Submissions and Amendment Report

Penrith Stadium Refurbishment

Submitted to the
Department of
Planning, Housing
and Infrastructure
on behalf of
Infrastructure NSW

SSD-68292713

Figure 3 Overshadowing diagrams illustrating potential buildings identified in Chapter E11 of Penrith Development Control Plan at winter solstice

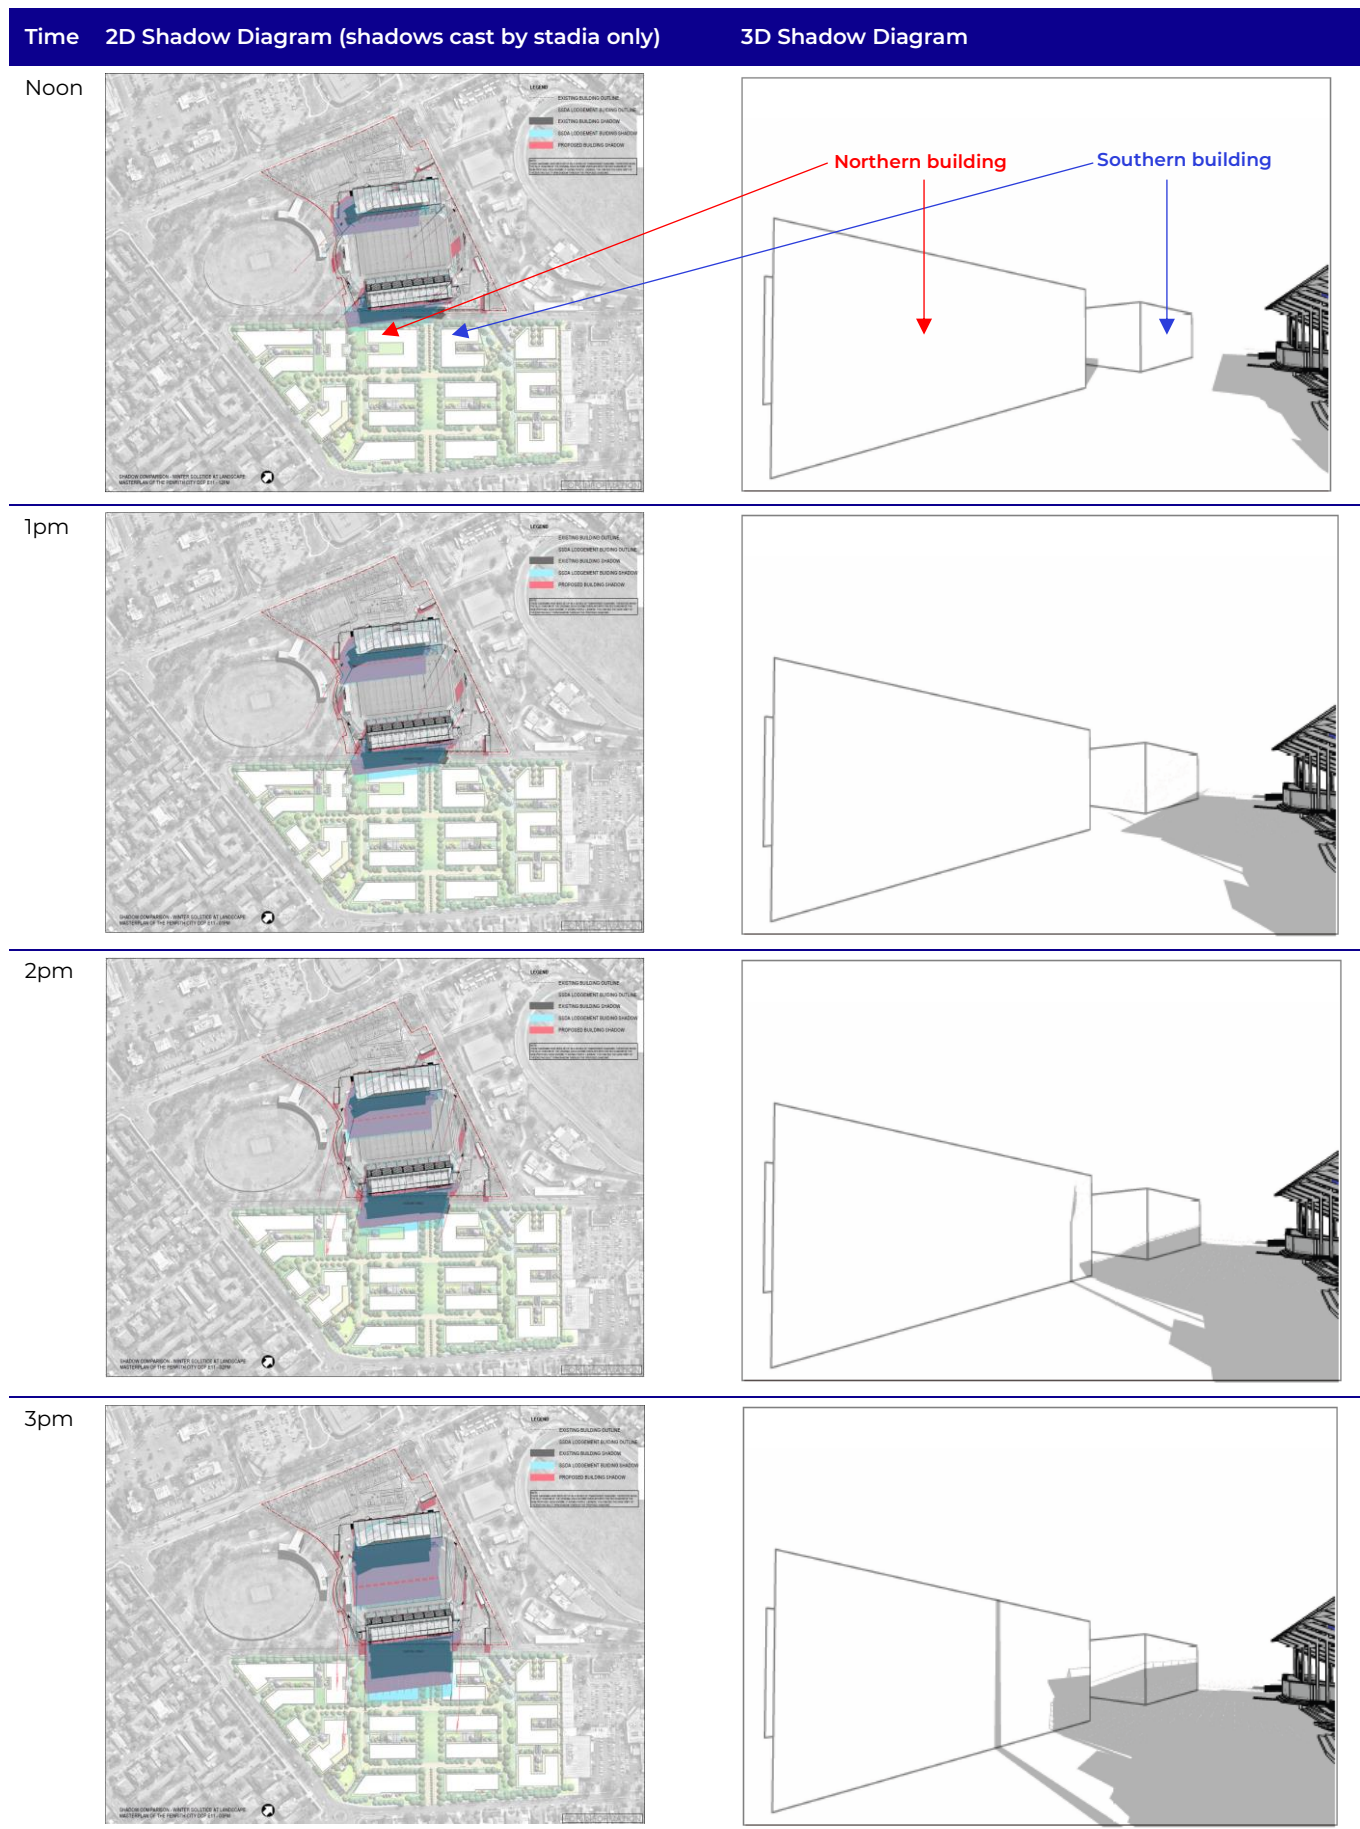
Following exhibition, DPHI requested further assessment be undertaken to demonstrate that future development of the 164 Station Street site is capable of achieving appropriate sunlight access to future residential dwellings following Penrith Stadium Refurbishment. As outlined in **Section 6.6**, no development consent has been issued for the design or construction of residential buildings for the 164 Station Street site. DPHI requested that shadow diagrams overlaid on Figure 2 from Chapter E11(C) of the Penrith DCP, being the landscape masterplan. It is necessary to note that the landscape masterplan and other diagrams contained within the Chapter E11(C) of the Penrith DCP are indicative, and any future Development Applications would have the capacity to significantly depart from the indicated layouts of buildings and open space in accordance with the development assessment framework in respect of the role of DCPs as set out by Sections 3.42 and 4.15(3A) of the EP&A Act. If future development of the site is SSD under State Environmental Planning Policy (Planning Systems) 2021, then the Penrith DCP would not apply at all.

Figure 3 demonstrates overshadowing arising from the Penrith Stadium Refurbishment at the winter solstice (i.e. worst case) commencing from 12pm, with more detailed versions of these images and diagrams for the period prior to 12pm (when no overshadowing of potential buildings would occur) provided at **Appendix O**. The two-dimensional diagrams also illustrate shadows cast by the existing stadium, and shadows cast by the proposal as exhibited. The effect of the design changes to the East Stand outlined in **Section 4.0** is that overshadowing is reduced in comparison to the exhibited design.
